DEVELOPMENT DETERMINATION PANEL MEETING

WEDNESDAY 30 APRIL 2025

ITEM 3.1 DA2024/1619 - 1164 BARRENJOEY ROAD, PALM BEACH - DEMOLITION WORKS AND CONSTRUCTION OF A DWELLING HOUSE INCLUDING SWIMMING POOL
--

DEVELOPMENT APPLICATION ASSESSMENT REPORT

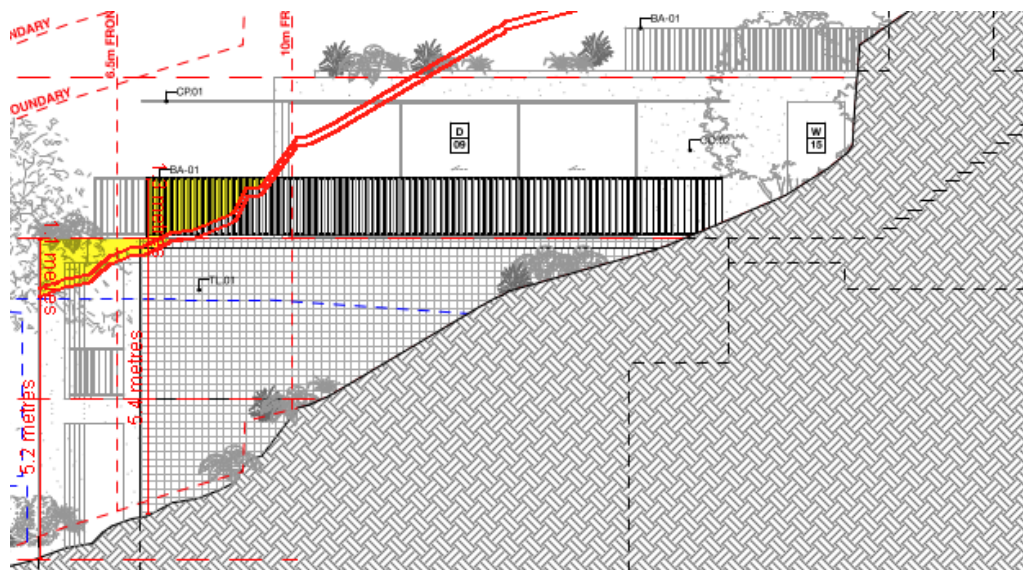
This control provides a building envelope projected at 45 degrees from a height of 3.5 metres above ground level (existing) at the side boundaries to the maximum building height applies to the site. The proposed development includes substantial breaches to the building envelope at both the eastern and western side elevations, shown below:

Above: The portions of the development that breach the building envelope on the eastern elevation, shown in yellow.

Above: The portions of the development that breach the building envelope on the western elevation, shown in yellow.

Figure 2: Original Design

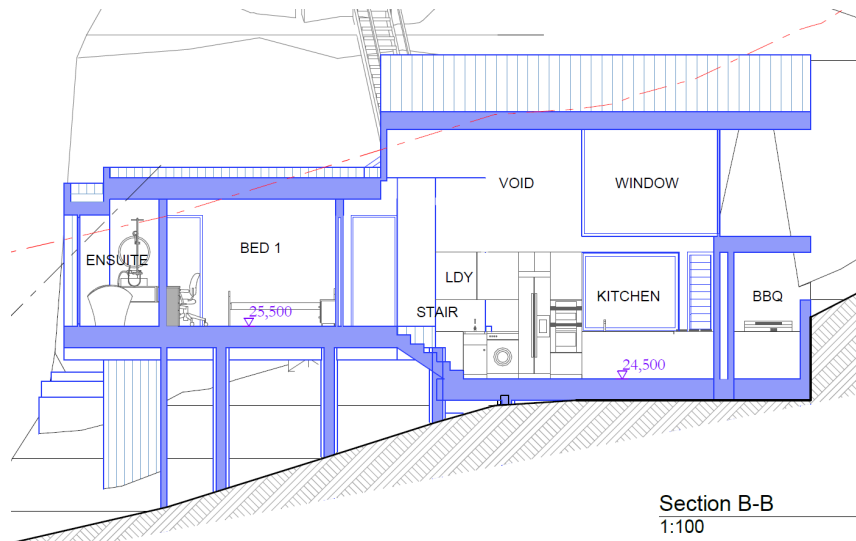
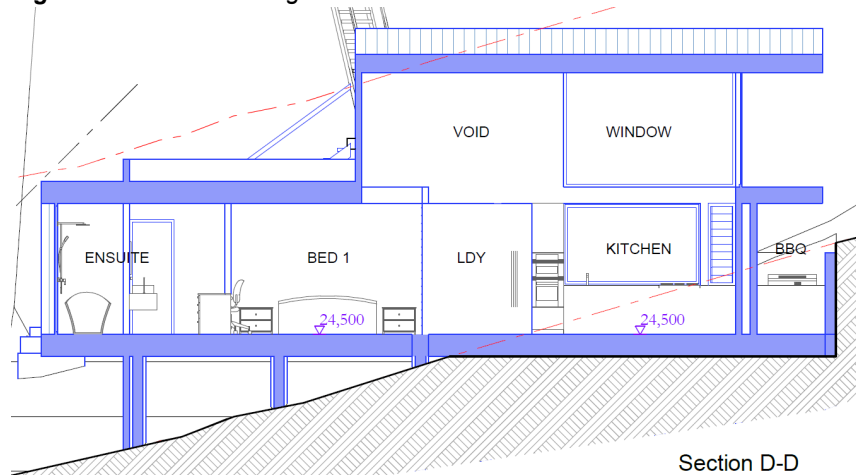
Amended plans submitted on 20 March 2025 lower the dwelling such that the extent of undercroft area is reduced (refer Figures 2 and 3). It is not considered necessary to condition this space as non-habitable.

Figure 9: Southern Elevation - Amended Design

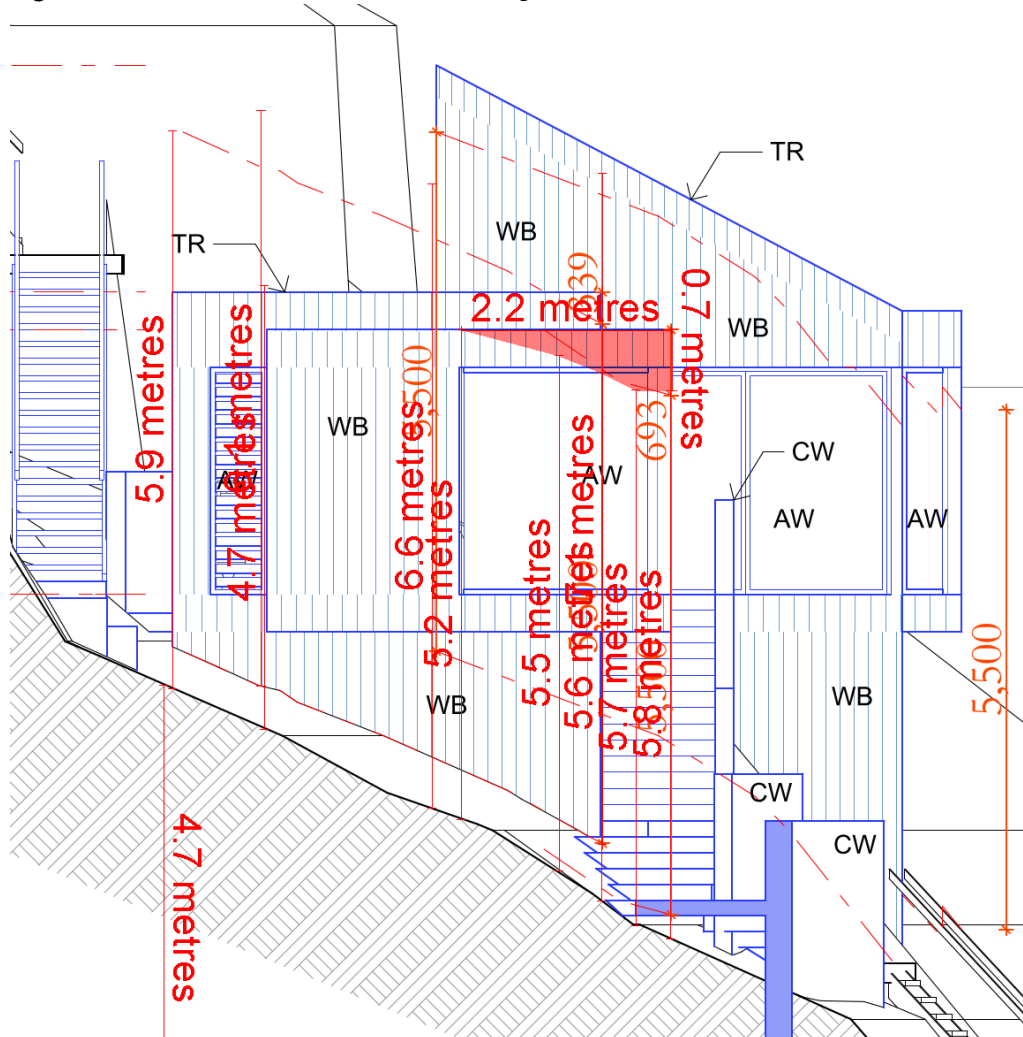
The southern elevation presents an encroachment of between nil and 0.7m in height for a length of 2.2m, resulting in a maximum variation of 12.1% (0.7m), as shown shaded red at Figure 9 below.

It is important to note that this envelope breach is only for a very small corner of the southern elevation and the site slopes steeply at approximately 55% at this portion. Additionally, the southern wall at this point is compliant with the southern side building line of 1m at 1.2m to 2.3m. Furthermore, the site and neighbouring properties are highly vegetated towards the rear half (refer Figure 10), and therefore the southern elevation does not pose any potential amenity impacts. The envelope breach also does not include any glazing.

Figure 11: Southern Elevation - Original Design

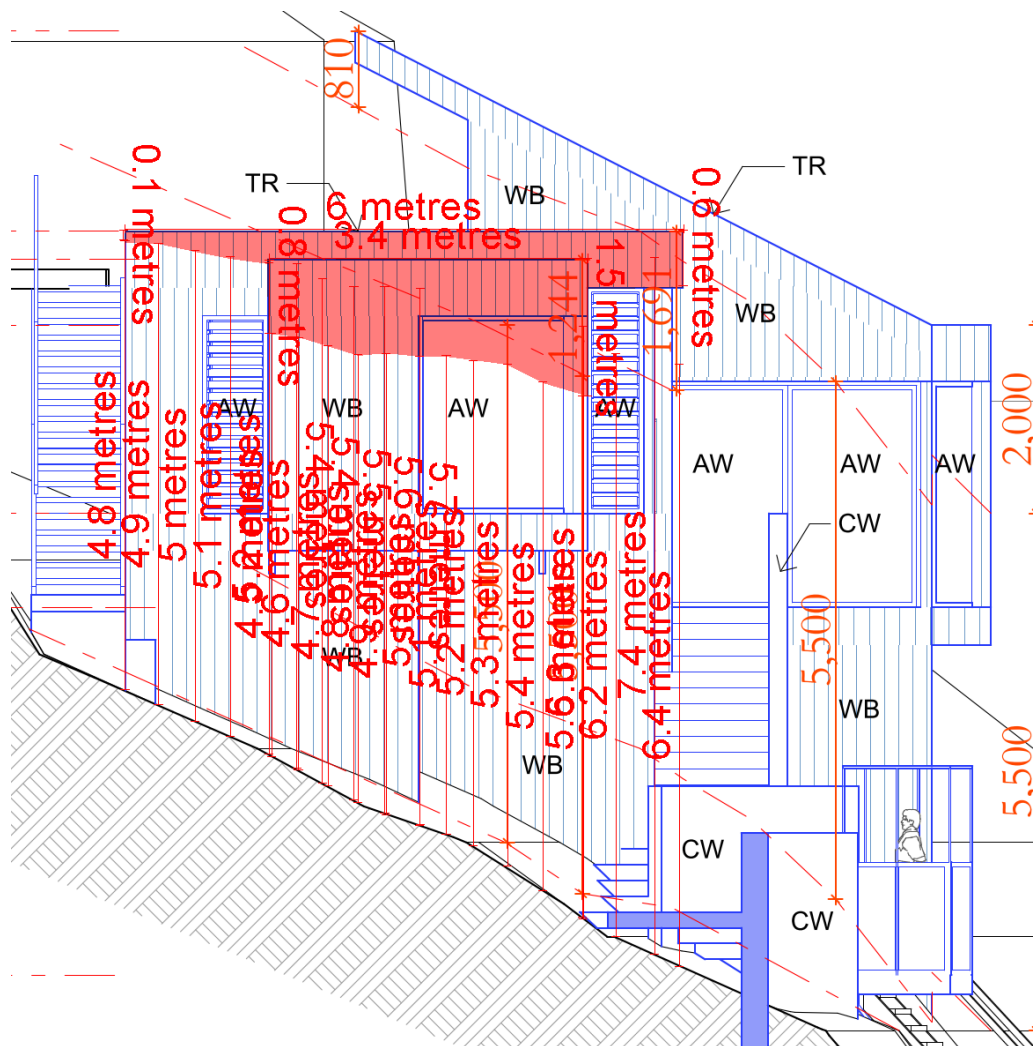
It is also important to note that the original design presented an encroachment of between 0.1m and 0.6m in height for a length of 6m, and an encroachment of between 0.8m and 1.5m in height for a length of 3.4m, resulting in a maximum variation of 27.8% (1.5m), as shown shaded red at Figure 11 below.

Figure 1: Overland flow path as approved

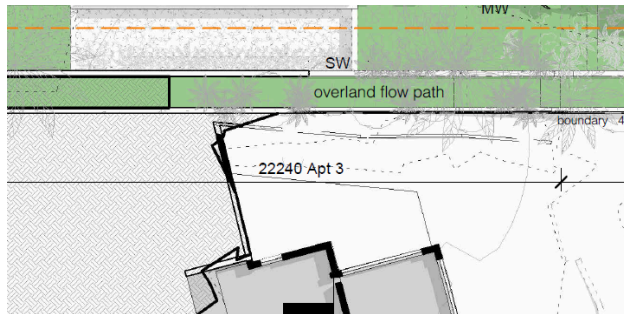
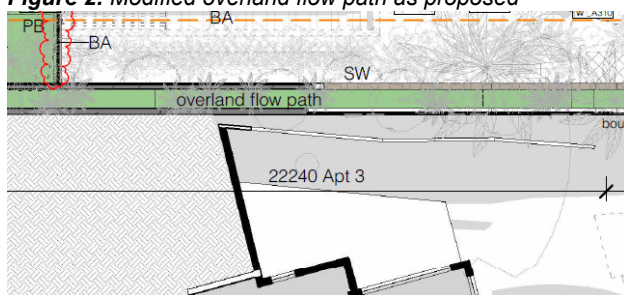
The changes to the overland flow path have been assessed by Council's Development Engineer, who is satisfied that the width of the overland flow path is consistent with the design plans submitted by the Civil Engineer and is acceptable (refer Figures 1 and 2 below). The overland flow path was adjusted in width to comply with Condition 19 of consent REV2021/0034, requiring the width of the overland flow path to be reduced from 1m to 0.6m, and the setback between the overland flow path and the southern elevation to be increased by 0.4m. Condition 26 also requires the perimeter walls of the overland flow path to be watertight to ensure no flows enter the site or adjoining property. As such, Council's Development Engineer has advised that the modified design will be less likely to result in overland flows onto the neighbouring property than the previous design. The Project Architect confirmed that the levels of the overland flow path have not changed. Council's Landscape Officer has reviewed the modified plans with respect to the neighbouring tree in question and advised that the impact to the southern neighbouring trees were assessed by the Arborist at the boundary line in 2021 and therefore no further impact is foreseen. Condition 36 has been amended as part of this consent to require the Project Arborist to supervise the construction of the overland flow path along the southern boundary, including any associated retaining walls, within the tree protection zones of any neighbouring trees. It is noted that the Arboricultural Assessment approved as part of the original application stated that the location of concrete footings for the overland flow path wall will need to allow for the low likelihood that woody roots are encountered and that an arboriculturist will need to supervise these works. The recommendations of the original Arboricultural Assessment shall remain in place and be adhered to.

Figure 3: Approved Basement Plan

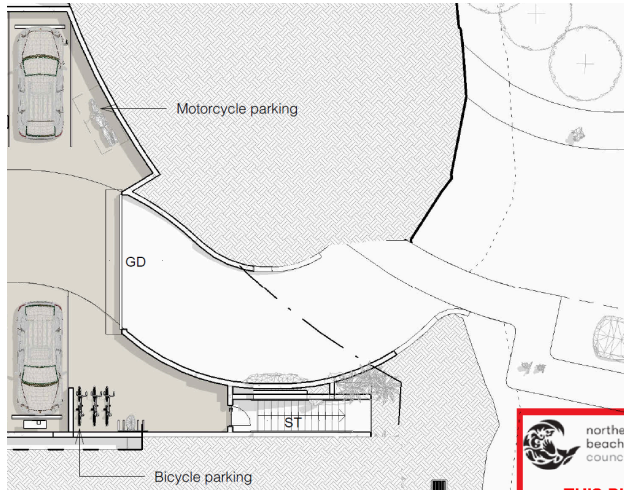
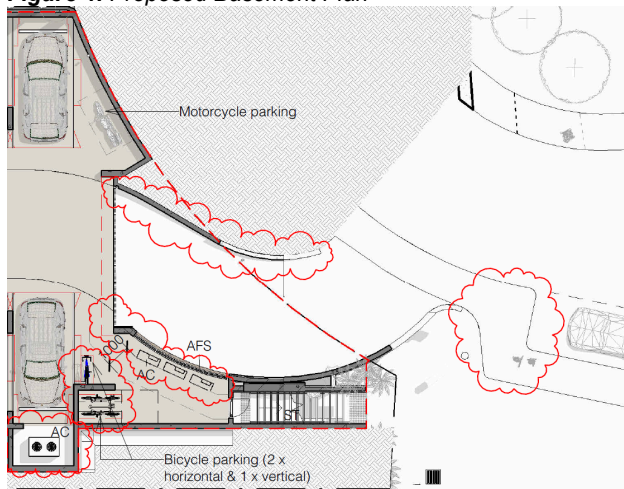
The footpath has been adjusted slightly to accommodate parking bay lengths that are compliant with Australian Standards; the changes do not force pedestrians further towards Surf Road, but rather improve safety by increasing the width of the footpath at the bend, as evident in Figures 3 and 4 below. The loading bay as approved has not changed and has always been located west of the driveway.

Figure 5: Approved southern elevation at boundary

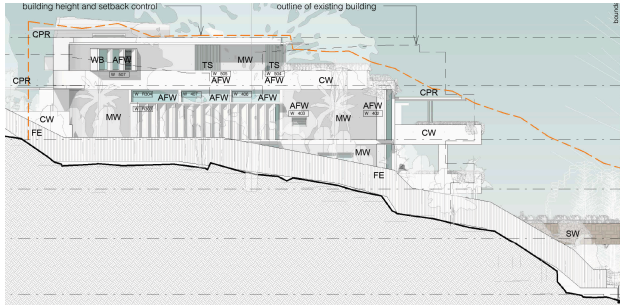
The setback of the building to the southern boundary is generally the same as approved in relation to the residential units. However, minor additions to the building have brought some components closer to the southern boundary - the inclusion of the AC at the basement, and lift and stairs to the outdoor seating area at the ground floor to comply with access and mobility design standards. These changes are not considered to have adverse amenity impacts due to the changes being below the existing ground level (refer Figure 5 and 6) and these components not directly interfacing the neighboring dwelling. The new sprinkler pump tank is entirely below ground and required for fire services. The area above the tank on Level 3 has replaced an entirely paved area to the boundary with a garden bed to the boundary, thereby softening the built form of the building.

Figure 9: Approved Level 3 Plan

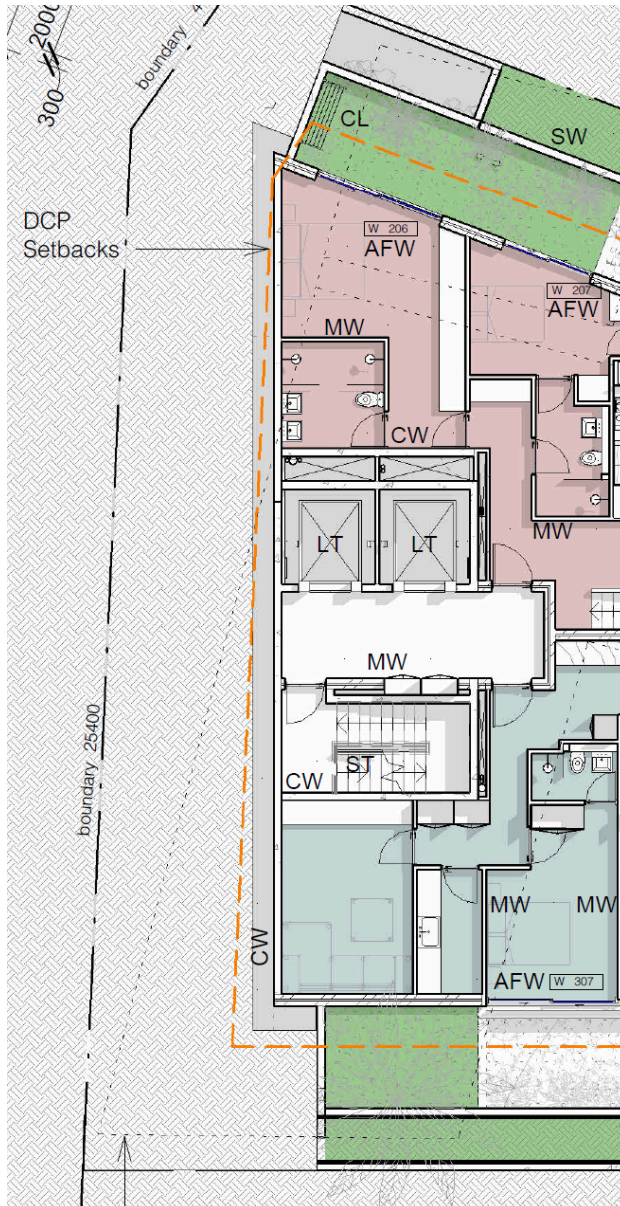
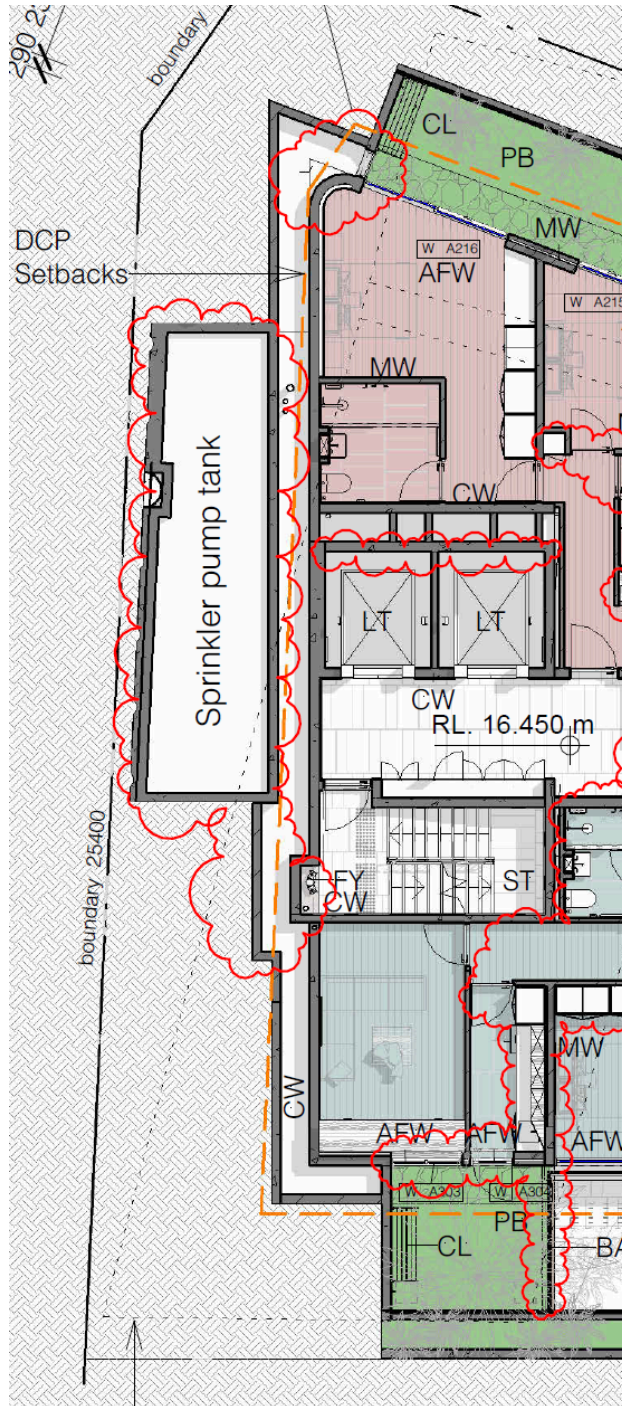
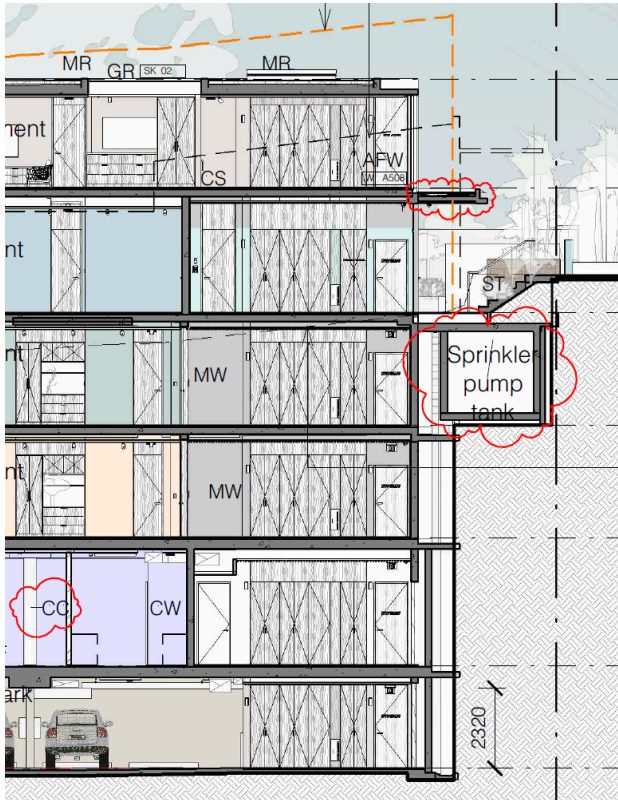
The proposed modifications include a sprinkler pump tank that is set back 0.3m from Whale Beach Road. It is important to note that the proposed sprinkler tank sits below existing ground level and is therefore not visible from the streetscape. The setback of the face of the development to Whale Beach Road remains unchanged. Refer Figures 9-11 below.

Figure 13: Proposed Basement Plan

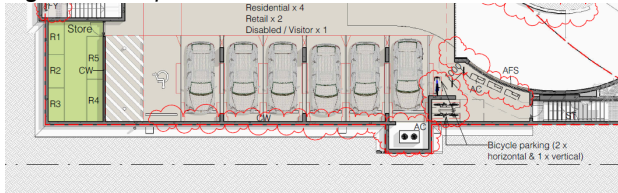
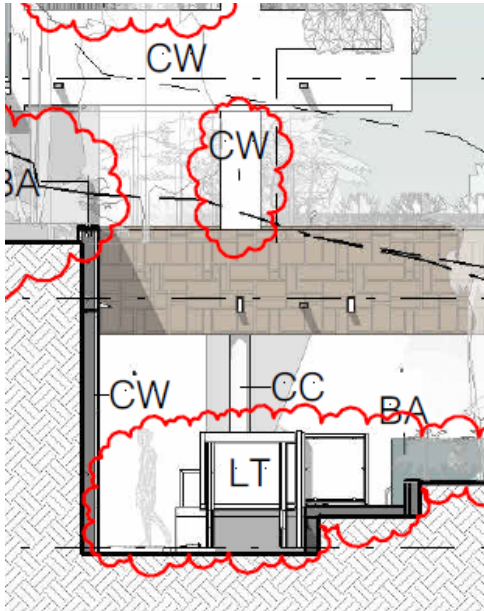
The basement and ground levels were approved with a 2.5m setback to the southern side boundary. The proposal as modified has a minimum setback of 0.7m at the basement level and 0.8m at the ground level due to the inclusion of the air conditioner and lift to the outdoor seating area to comply with AS1428.1 Design for access and mobility, as evident in Figures 13 and 14 below. The remainder of the building maintains the approved setback of 2.5m from the southern boundary at the basement and ground floor levels.

It is important to note that the ground floor sits approximately 5.3m below the existing ground level and 6.8m below the height of the fence, as evident in Figure 15 below. As such, these added components pose minimal amenity impacts for adjoining properties.

Image 1: Height of building variation.

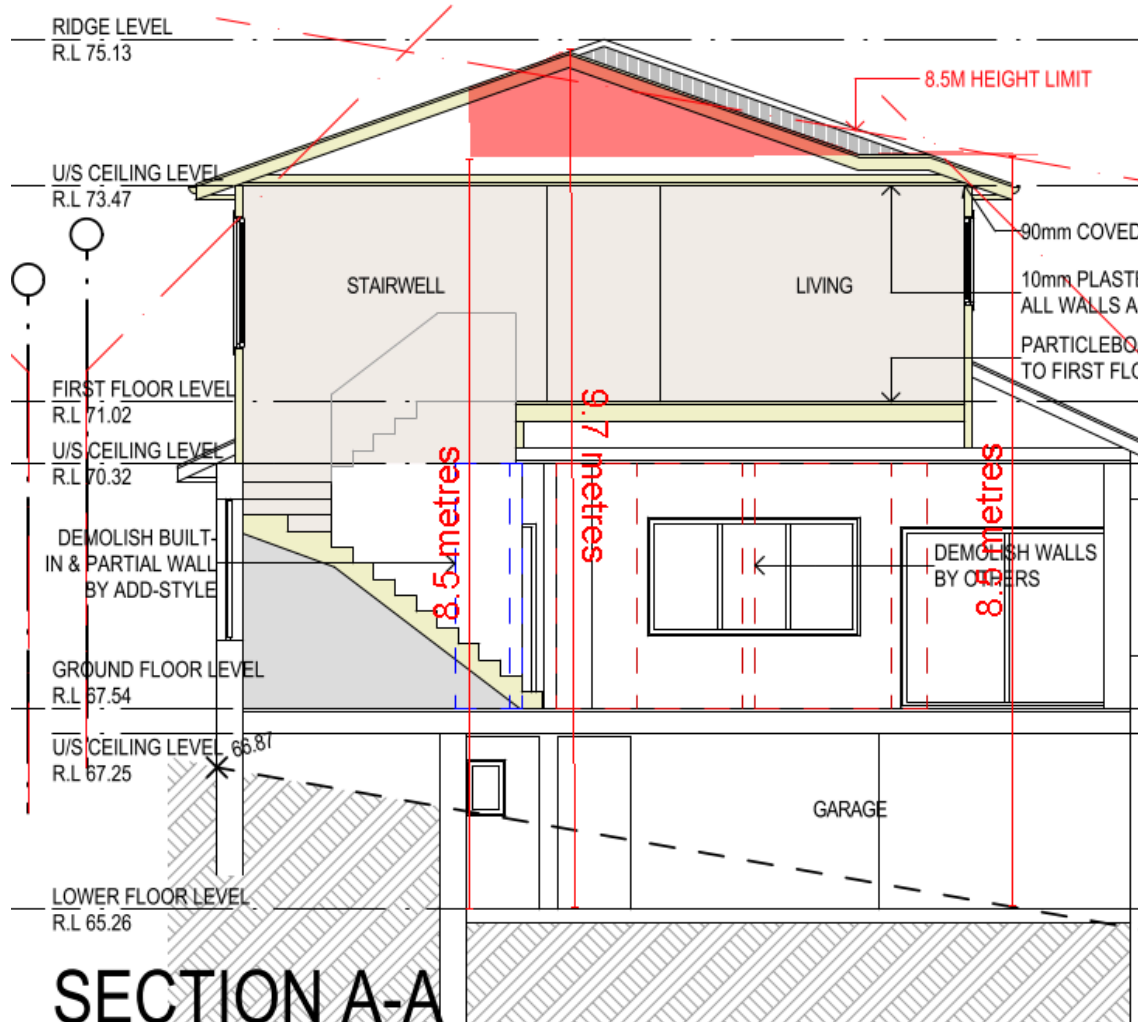
Percentage of variation: 14.11%

Image 1: Ground floor front and northern side boundary non-compliance.

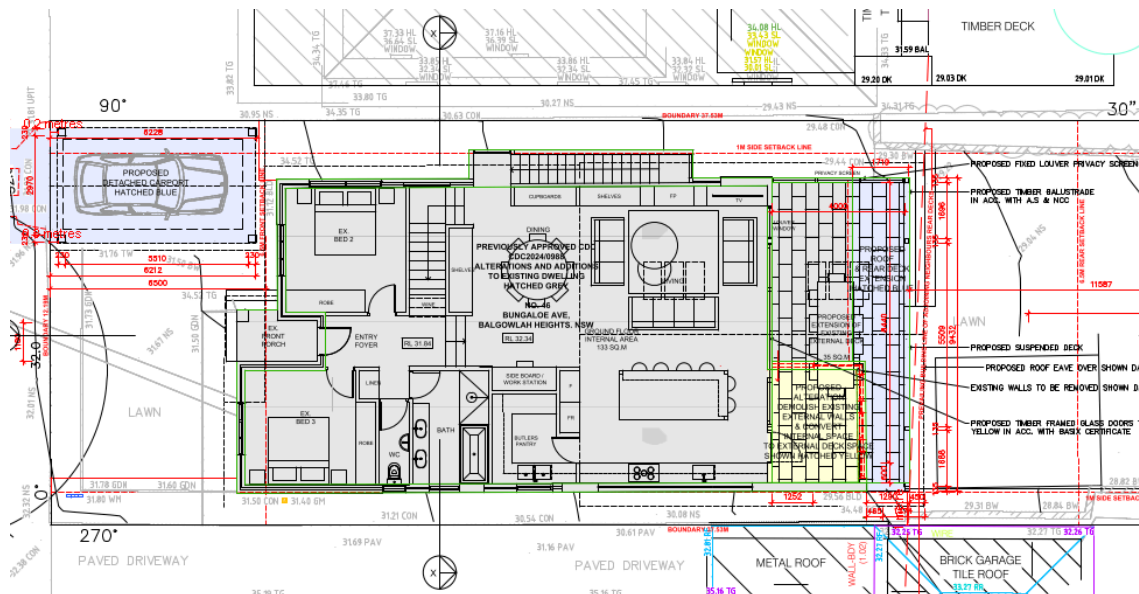
Clause 4.1.4.2 of the MDCP requires development be setback at least one third of the adjoining wall height. The development proposes to extend the height of the existing external walls, maintaining the existing setback to the side boundary of 1.6m, to the northern side boundaries.
